9 July 2020

Project: Powerhouse Parramatta

Reference : SSD-10416

Jemena Asset Management Pty Ltd on behalf of Jemena Gas Networks (NSW) Ltd (collectively Jemena) has reviewed and assessed the SSD with respect to safety and impacts on or from the Jemena gas main which traverses the land parcel (Lot 2 DP1247122) which is the subject of the State Significant Development application. A registered easement is on title (DP1235084) – Easement for gas mains 1 metre wide and variable width which favours Jemena and gives it the right to own, operate, maintain and access a gas main and associated apparatus.

Figure 5 - Surrounding Utility Gas Infrastructure

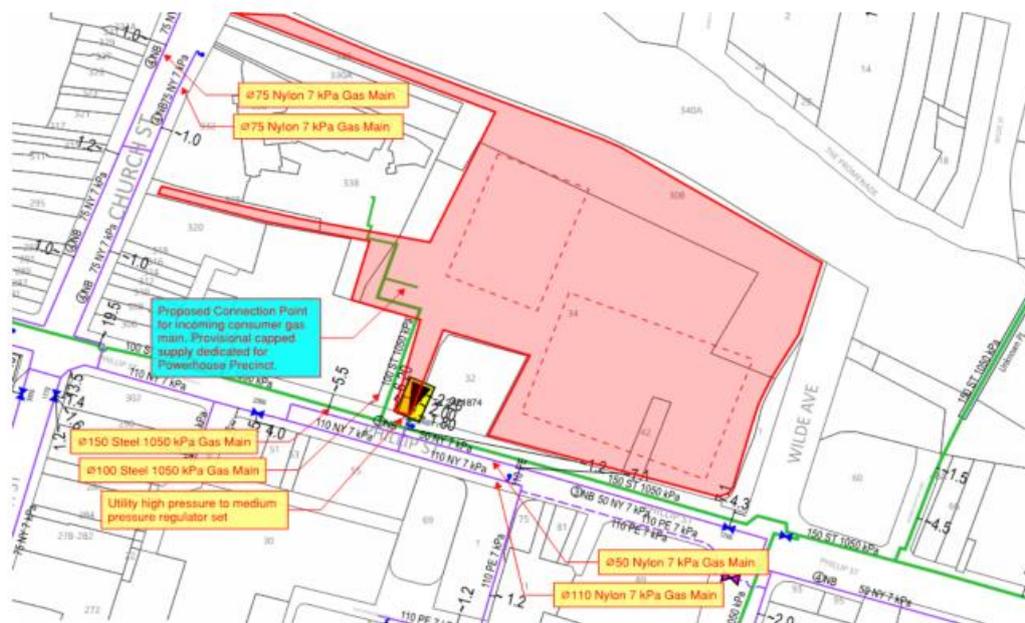
1. Jemena has a secondary gas main in the road reserve of Phillip Street and Dirrabarri Lane before it transitions into the development site. Jemena will request the project to determine the exact alignment and depth of cover of the secondary main within the land parcel and within the road reserve so that it can be adequately protected during the construction phasing. Any proposed works within the easement, including change in levels, will need to be submitted to Jemena for review.

3. The Concon regulator is currently situated within the footpath of Dirrabarri Lane. As the proposed works will have an impact on the Concon regulator, Jemena will request that the Concon regulator be relocated outside of the construction zone at the project's expense.

4. Any request for a new connection, augmentation of the gas main alignment, the removal or further isolation of the existing gas main will need to be coordinated through Jemena Gas Network Development (Zachary Kennett). Jemena has previously installed a stub contemplated a future connection point for gas into the property parcel (see highlight section in map below). ARUP have been advised of the stub connection as part of the early engagement with the Powerhouse project in April 2020.

- At a high level, any future meter room associated with the Powerhouse development, can be either external or internal room on an exterior facing wall on levels B1, Ground or Level 1. The service line between the below point and the meter can't be built on top of other than where it penetrates into an internal meter room.
